"REDI-ROCK" SEGMENTAL RETAINING WALL

PROJECT: EAST MONTPELIER BRF 037-1(7)
US ROUTE 2, EAST MONTPELIER, VT

SHEET TITLE: RETAINING WALL DESIGN SHEET 1

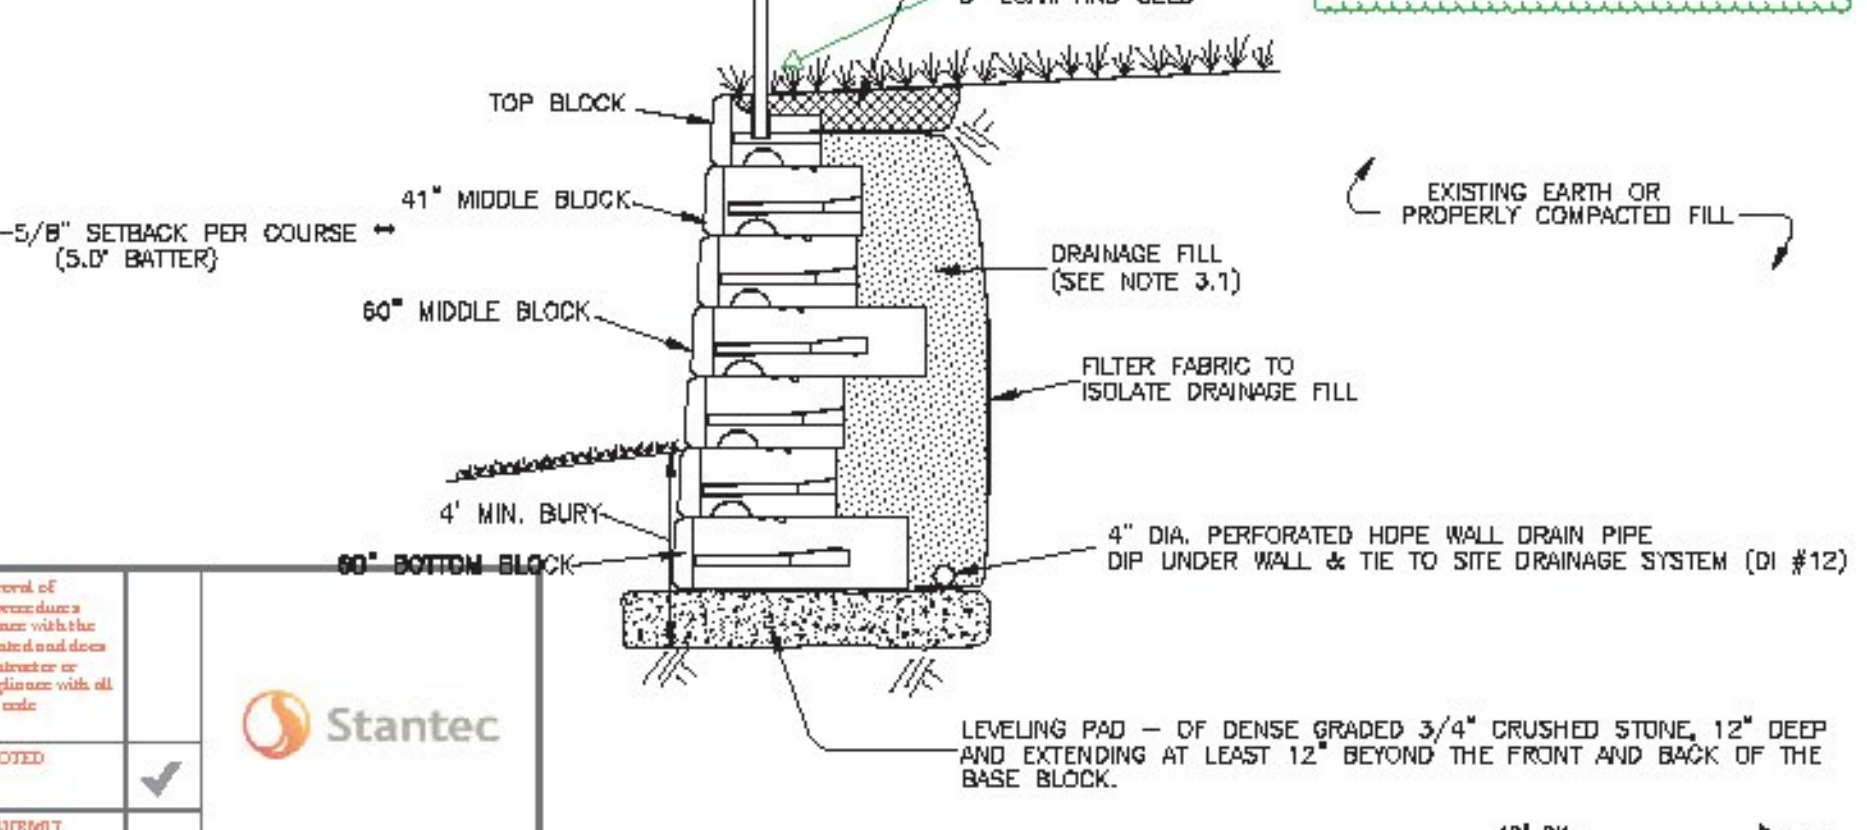
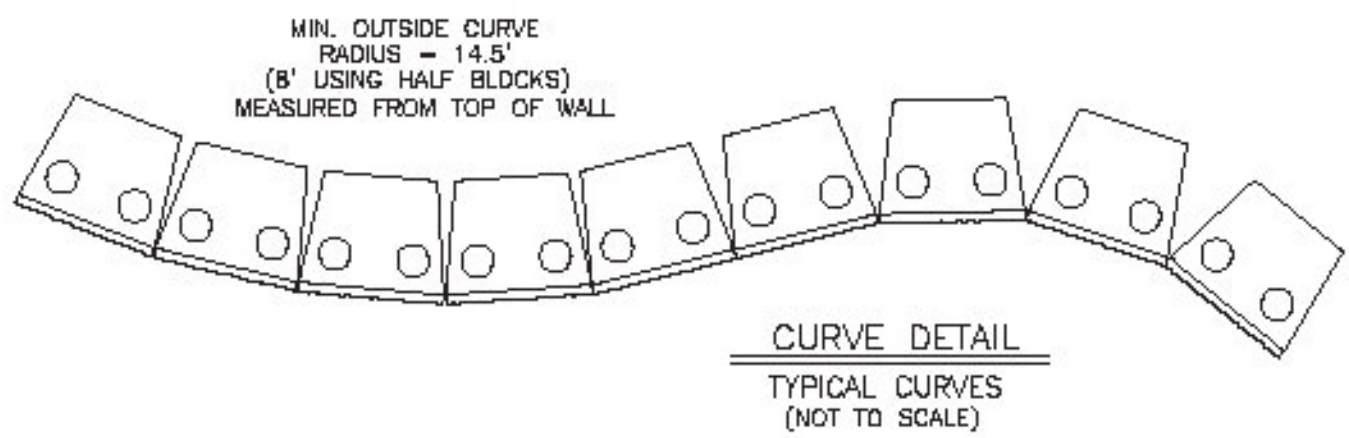
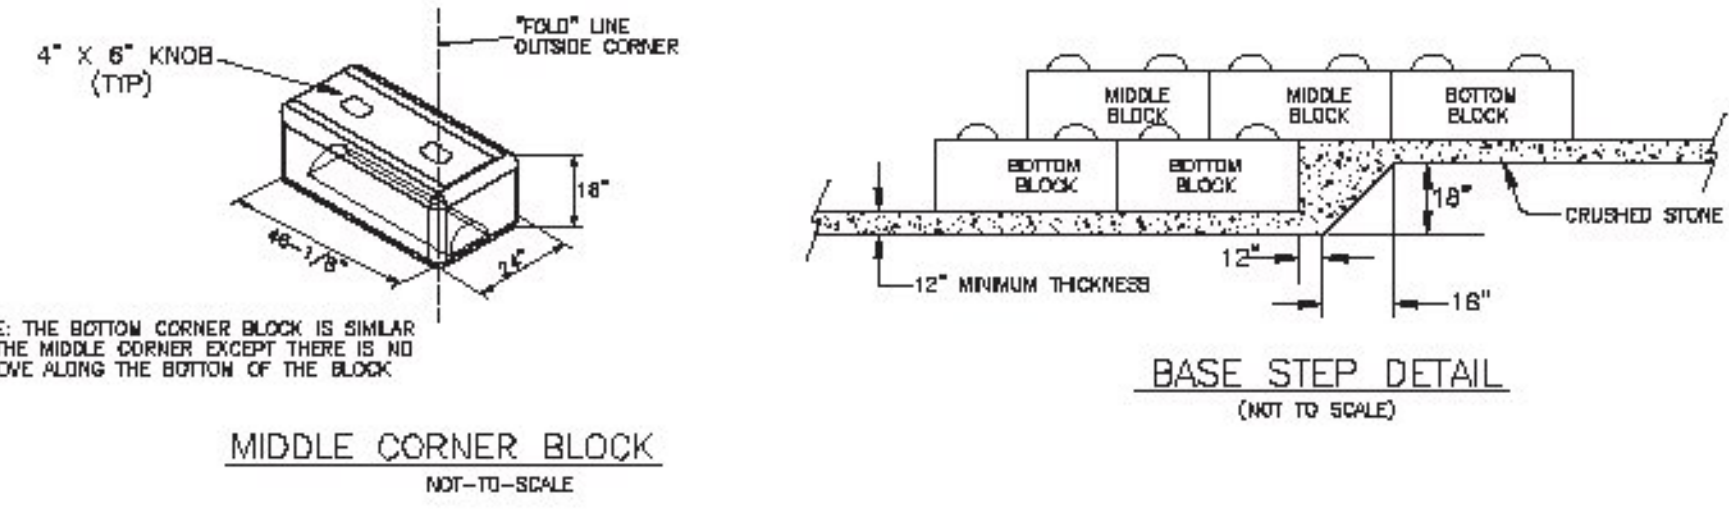
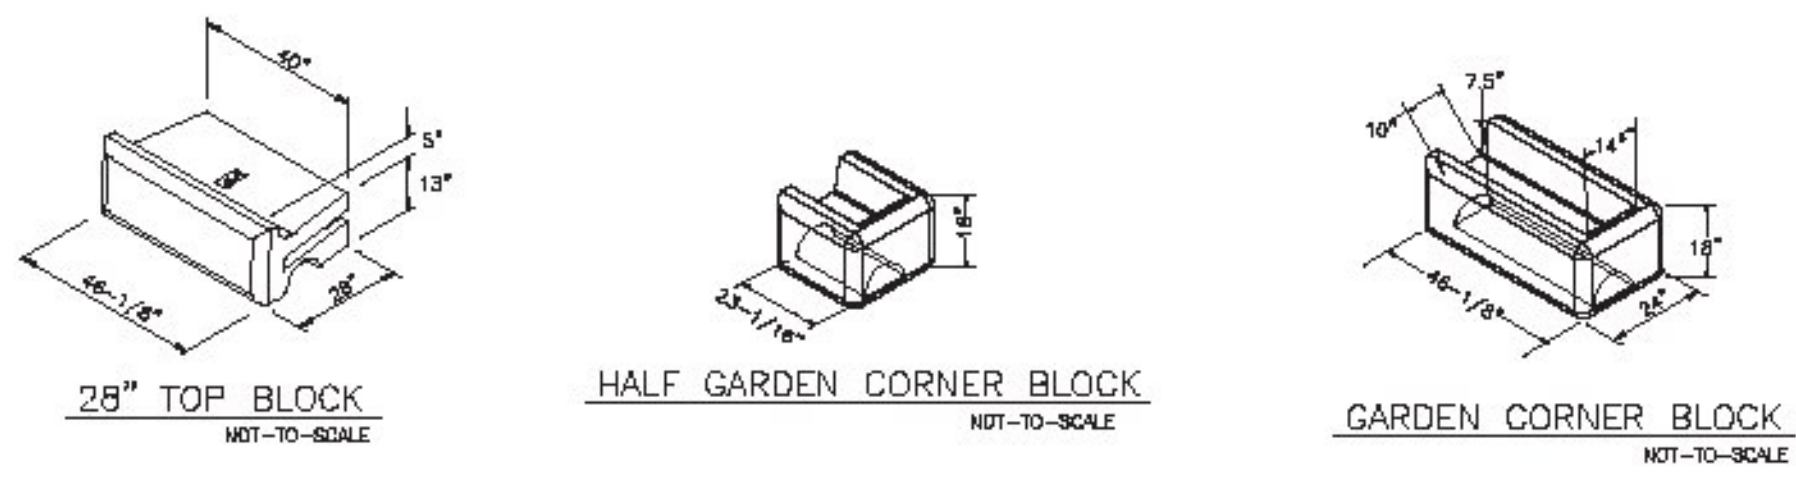
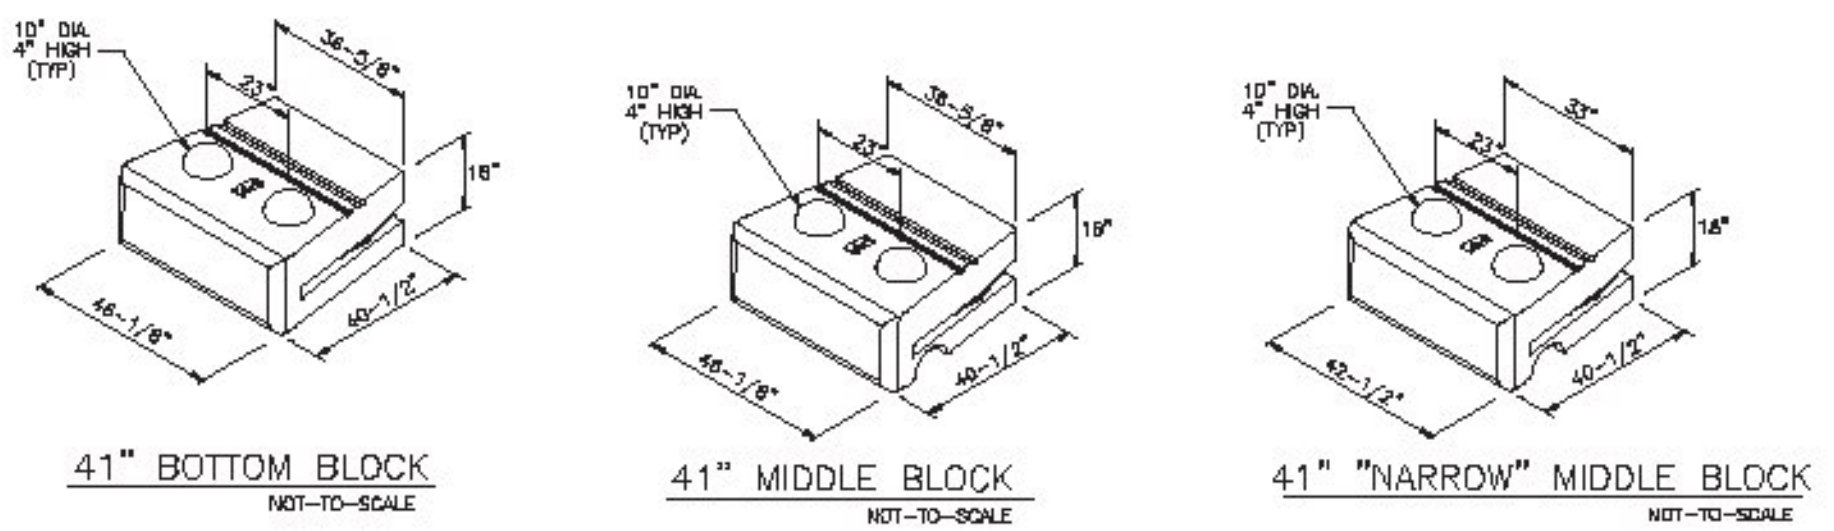
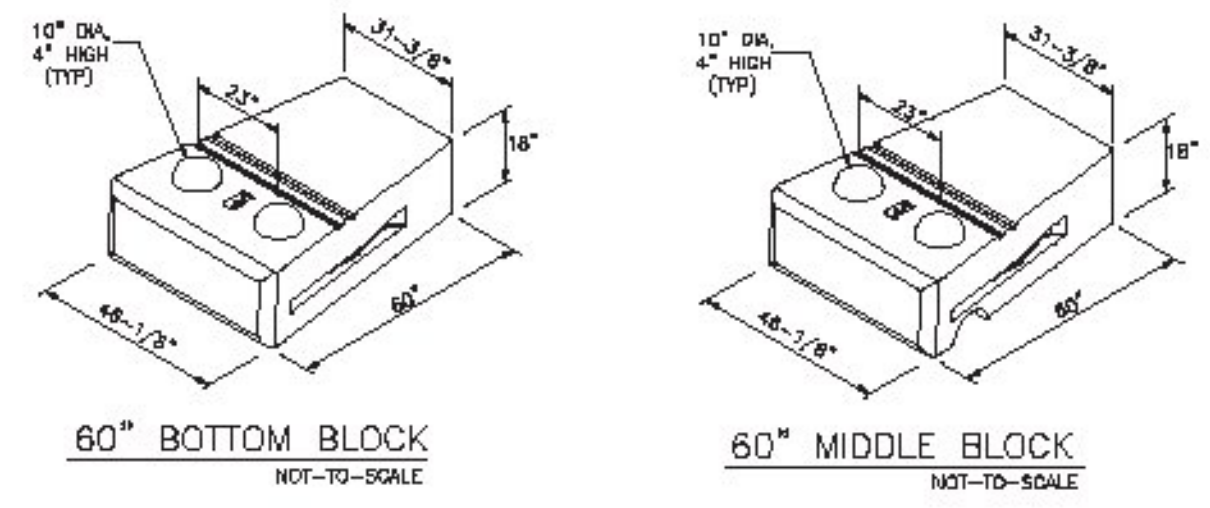
APPROVED AS NOTED: [Signature]

Please provide additional information on wall texture, integral color and stained color for approval before casting.
